Subject: RE: BESS study feedback and presentation Date: Thursday, September 19, 2024 3:49:27 PM

STACK'D SERIES

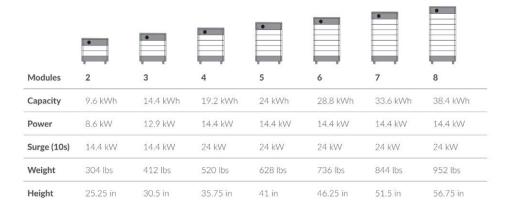
The 24-02 interpretation is referring to modular units which can be configured for varying capacities. This is obvious because question comes from Homegrid which sells units that can be configured between 9.6kWh to 38.4kWh

https://cdn.sanity.io/files/xcmp4e9i/production/90826f0975af48b98a2dd1a0963991e3870833e 6.pdf. If the capacity of one Stack'd Series unit is over 20kWh for the unit then \$1207.1 – .9 are applicable. For the current Stack'd Series (image below) 1-4 would follow SFFC \$1207.11 while 5-8 would follow \$1207.1 through \$1207.9.
